**Project SW111 - Crooked Creek Interceptor
Improvements Phase 2**

ADDENDUM No. 02

ISSUE DATE: January 3, 2024

Map: Temporary Flow Monitor Location Map

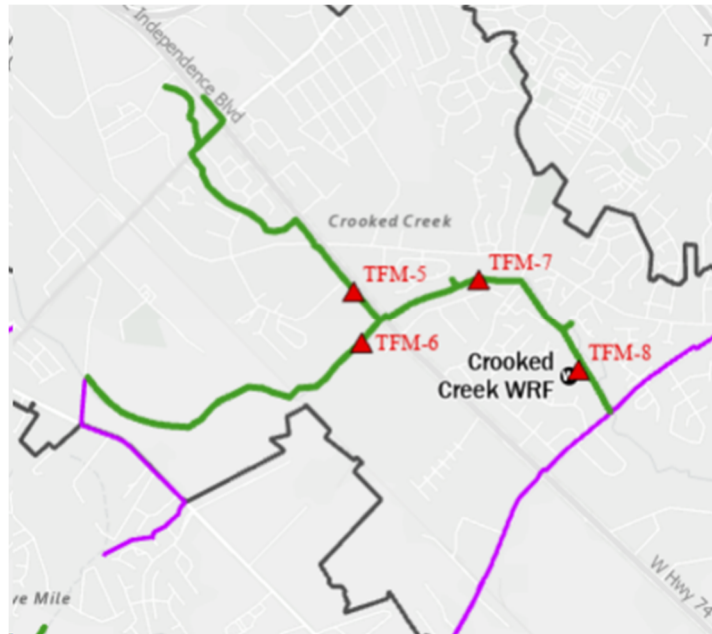
- RFI:** Do you have any flows on 8", 10" 12" sanitary sewer sidelines?

Response: See updated, attached specification 33 01 30.50 Sewer Bypassing and Dewatering, which includes a map and additional details of the estimated sewer flows. The Contractor is responsible for obtaining current flow condition information at the time of construction. The Owner is not responsible for any deviations in quantity of sewage flow at any time during the construction period. Higher flows may be encountered depending on weather and other upstream conditions.
- RFI:** The mainline we will bypass has 8", 12", 15", 18", 21" lines, trying to determine what flow you want us to bypass on each size line because the specs say the flow is listed as 1.6 average daily flow and peak flow of 7.5 MGD. What flow is that 7.5 MGD based on, out of MH33129, after the 21" and 18" SS lines have combined into the outgoing 30" SS line?

Location	Average Daily Flow (mgd)	Peak Hour Flow (mgd)
TFM-5	0.38	1.62
TFM-6	0.52	2.93
TFM=7	1.04	4.78
TFM-8	1.61	7.49
